## Baffinland Iron Mines LP Mary River Expansion Project

### Construction Summary Report: Mary River Tank Farm (2019)

**DETAIL**  
TEMPORARY SILT FENCE DURING  
CONSTRUCTION IN RAINY SEASON  
SCALE: 1:20

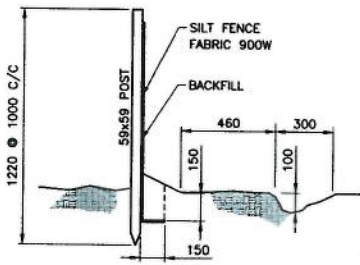
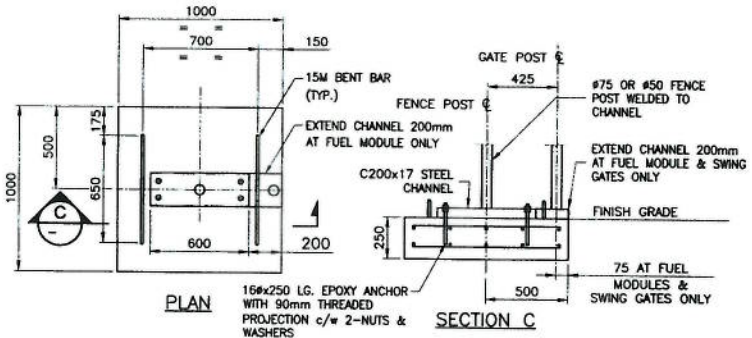
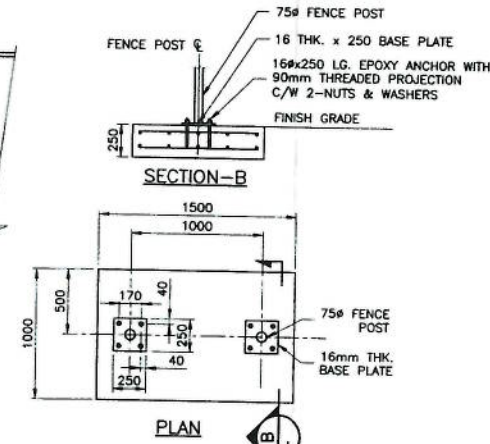
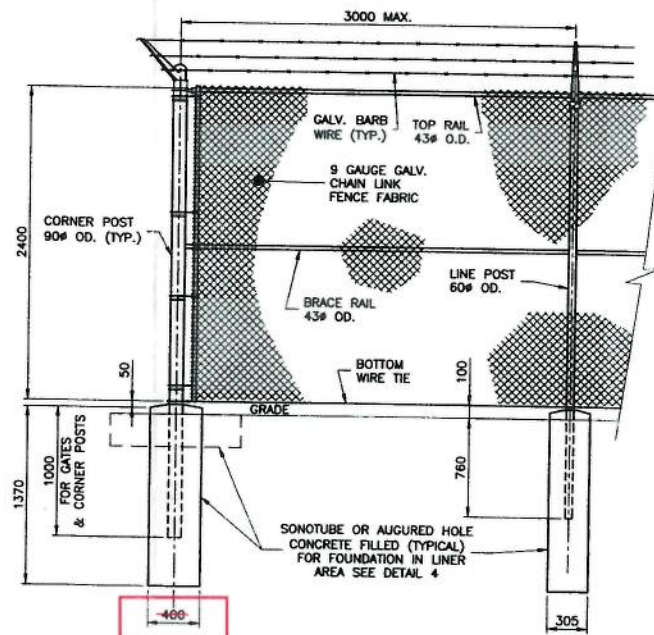
Fence Post holes changed to 305mm per RFI-0013

H353004-10000-220-273-0002-0001

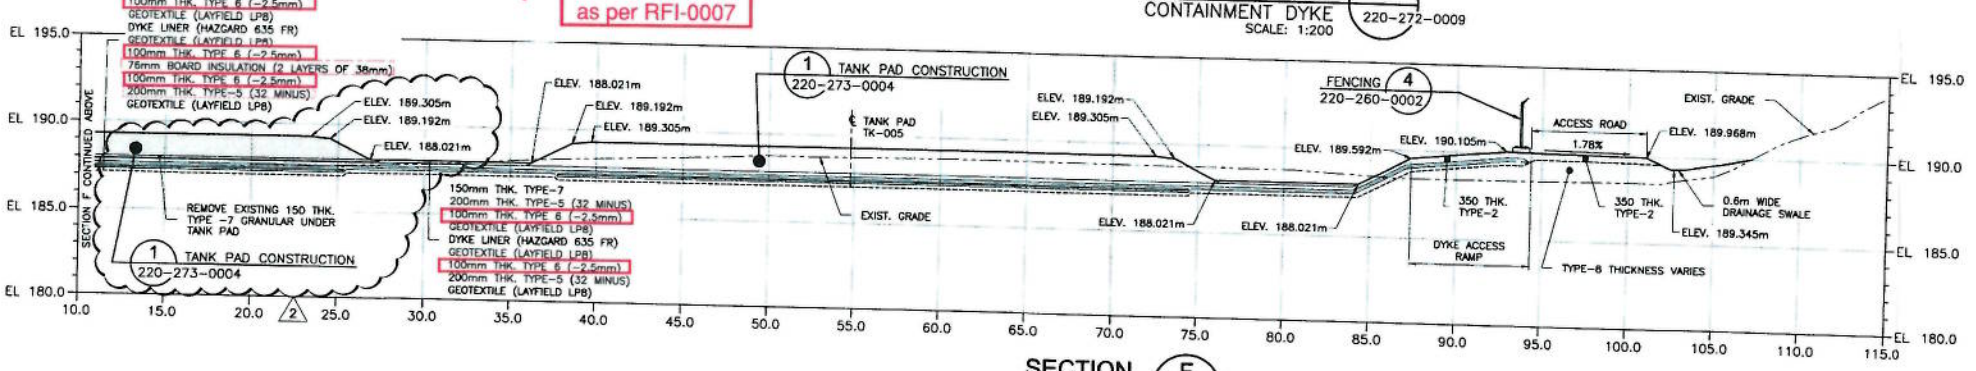
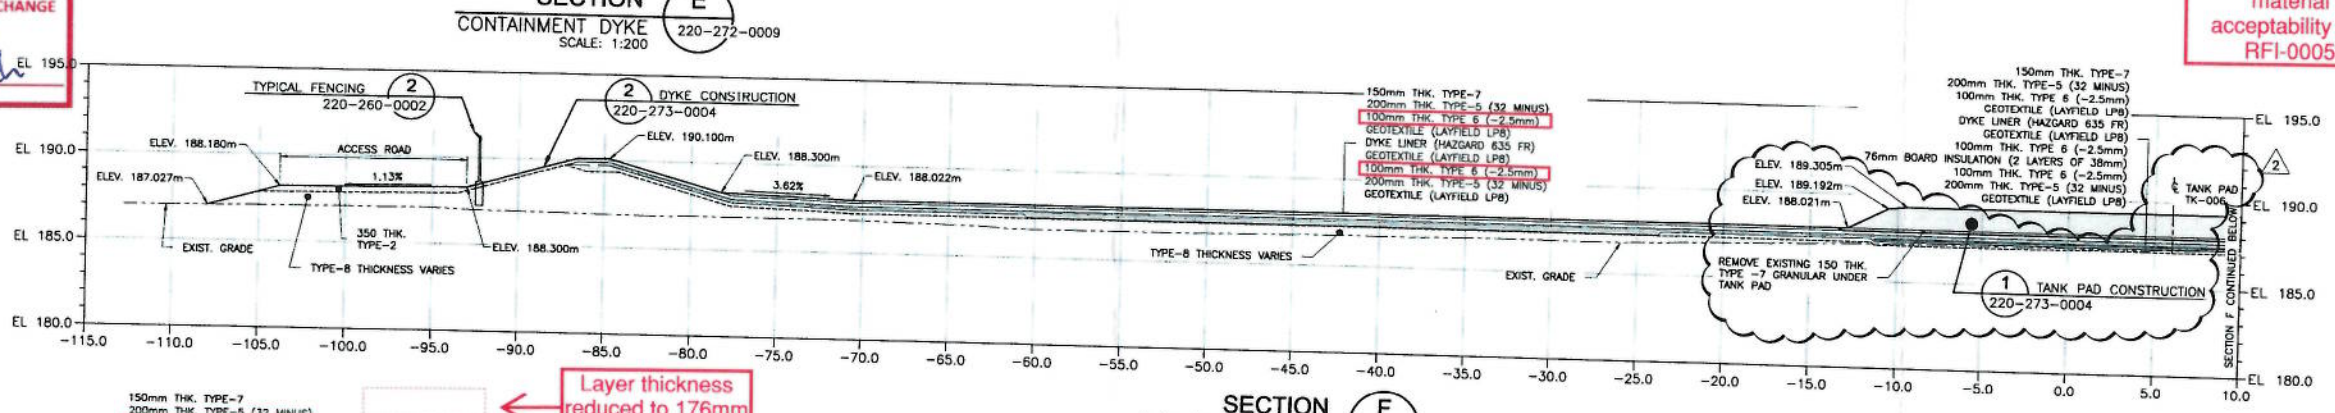
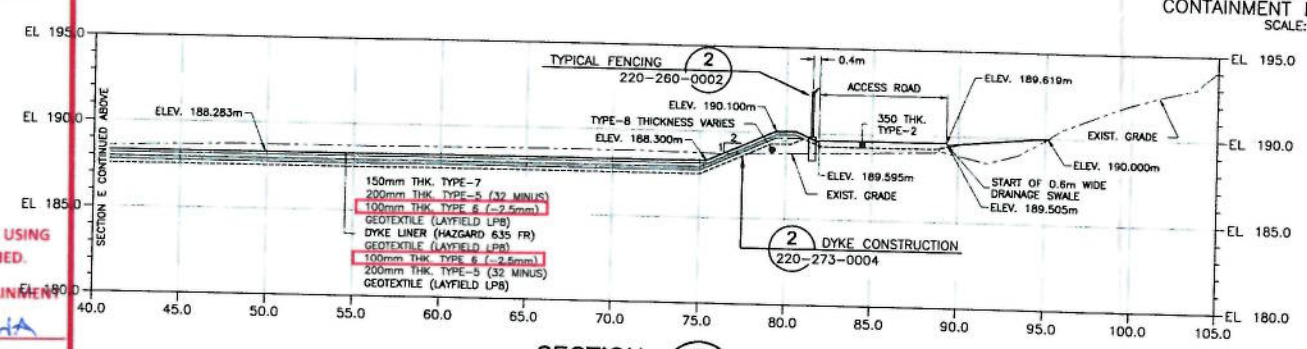
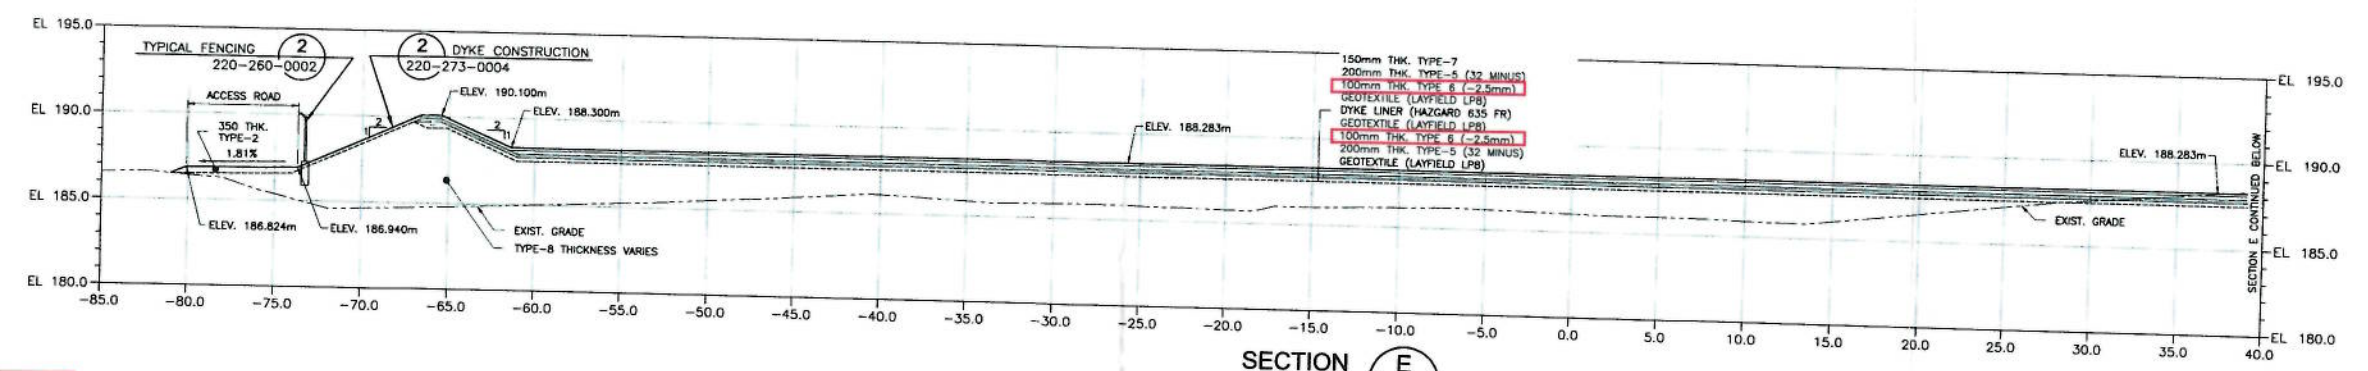
Option of areas of Type 6 material changed to Type 9 as per RFI-001 & Site screened material acceptability per RFI-0005

Board insulation thickness changed to 50mm as per RFI-0007

Layer thickness reduced to 176mm as per RFI-0007

SECTION G  
CONTAINMENT DYKE  
SCALE: 1:200

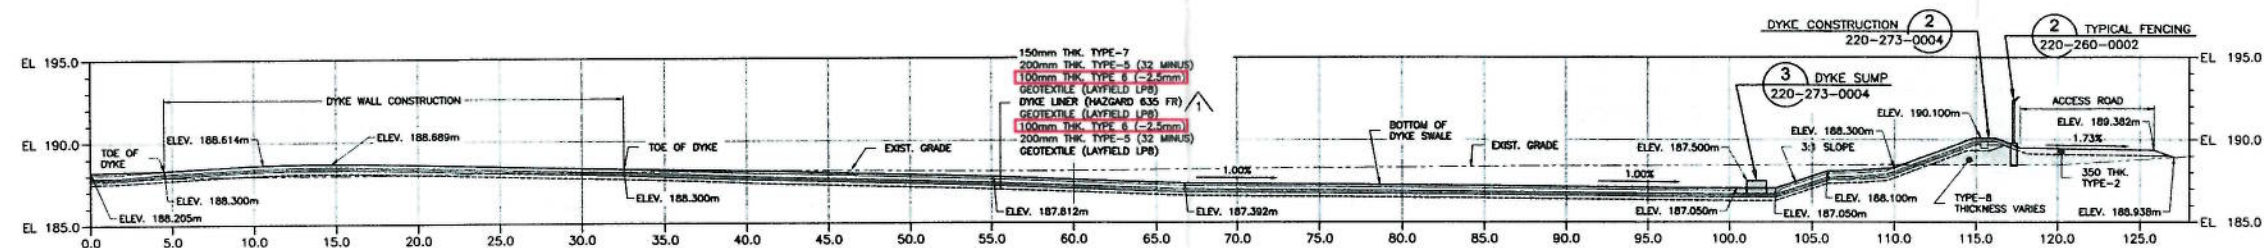
Option of areas of  
Type 6 material  
changed to Type 9  
as per RFI-001 &  
Site screened  
material  
acceptability per  
RFI-0005

DRAWING TITLE:  
Mary River Tank Farm  
Pedestal Foundation  
Tanks 5 & Tank 6 & Tank 7  
Insulation Asbuilt

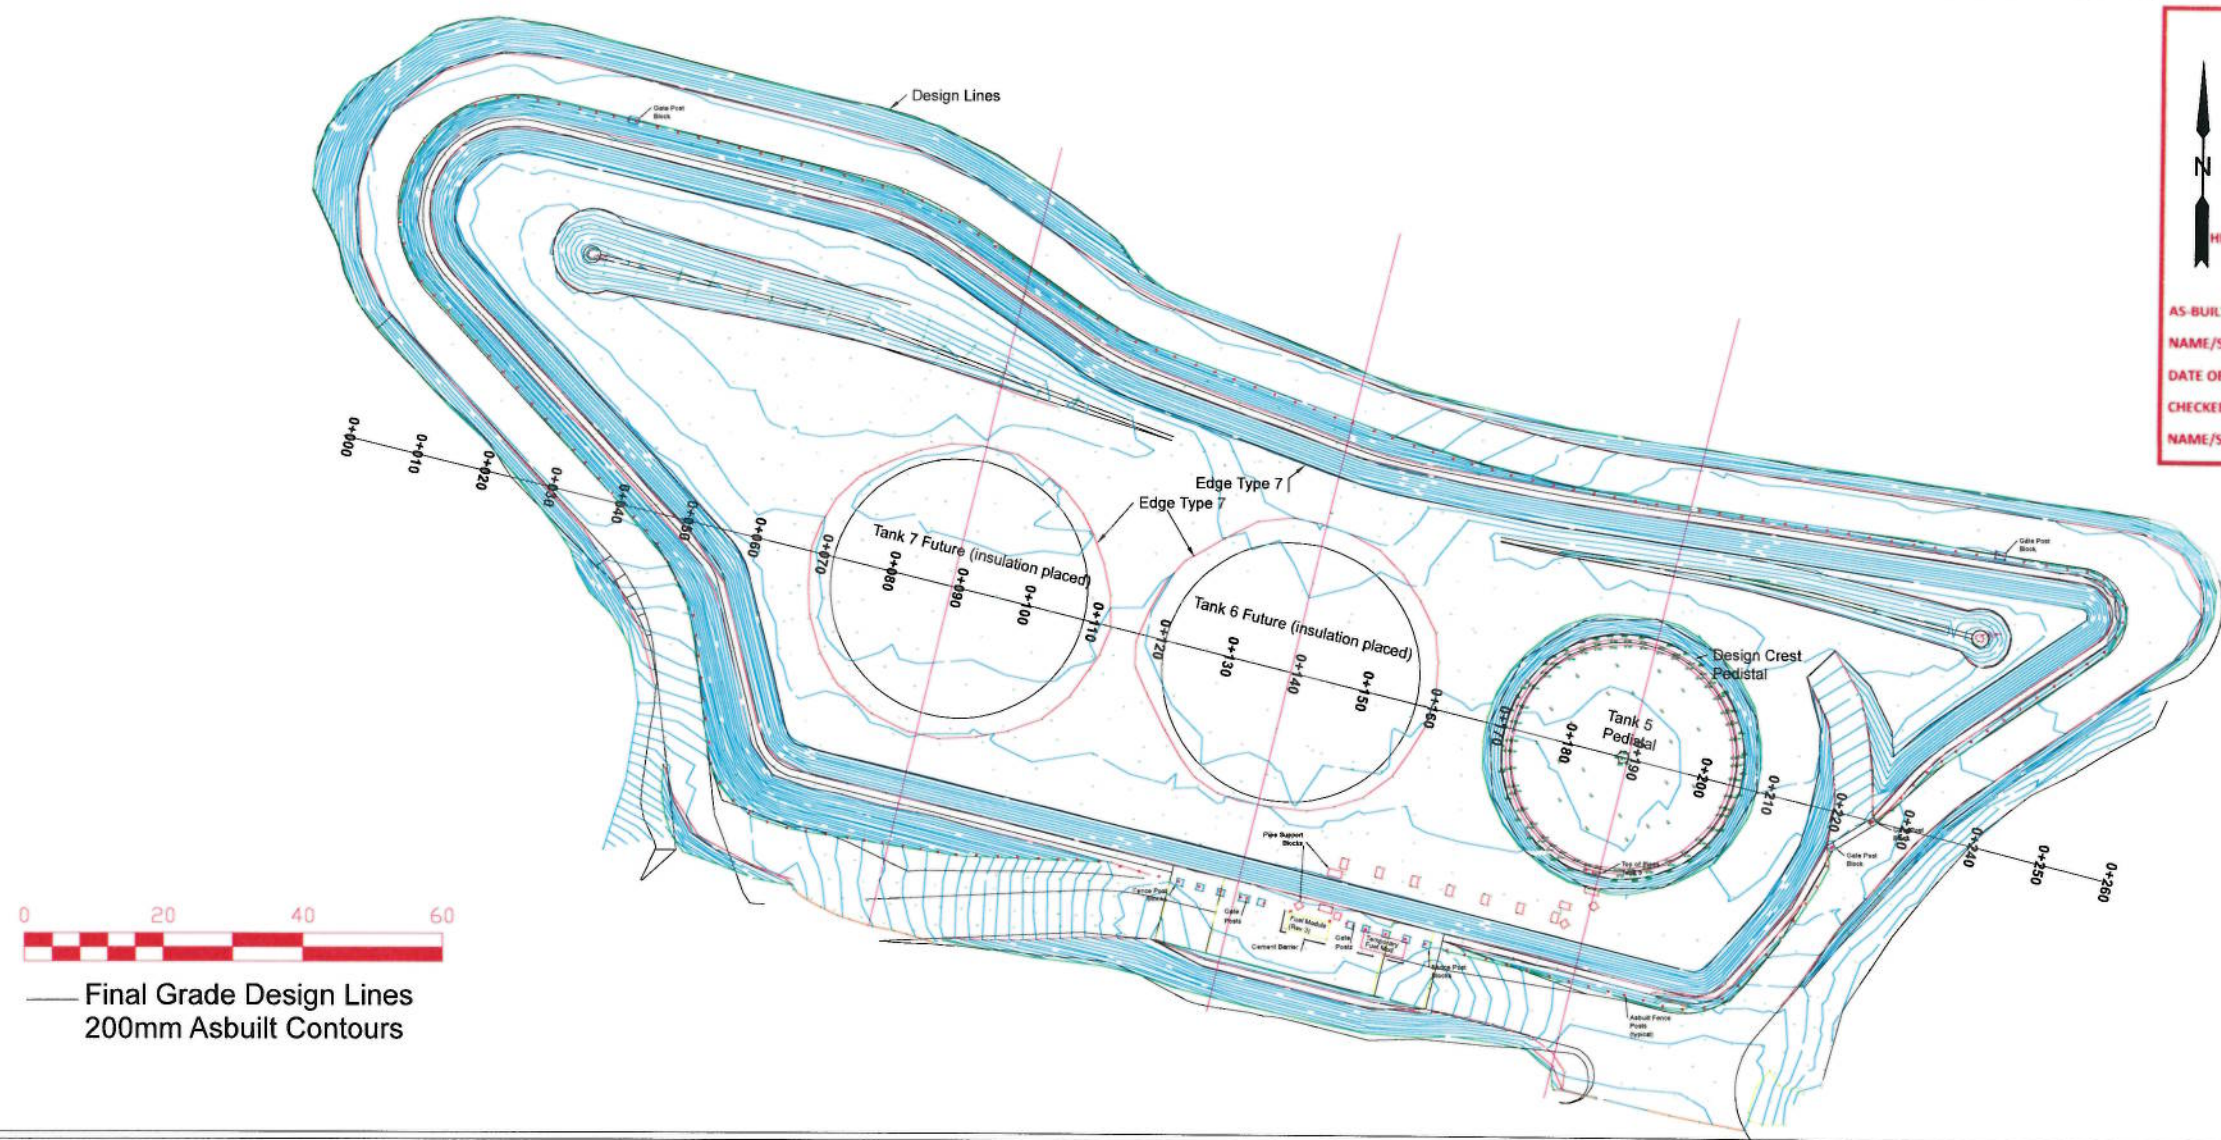
NOTES:  
Pedestal Subgrade Prepared based on IFC coordinates for Tanks 5 & 6, for Tank 7 as directed by Hatch  
Ref. drawing H35004-10000-220-272-0012-0001 Rev1 (Rev0 for Tank 7)  
NOTE Red Lines RFI 003 Pt# 705 change to 187.192 & pt # 710 change to 187.111  
Red Lines RFI 0010 Insulation thickness 100mm thus type 5 reduced from 200mm to 176mm  
Red Line References RFI-003, 005, 007, 0010.
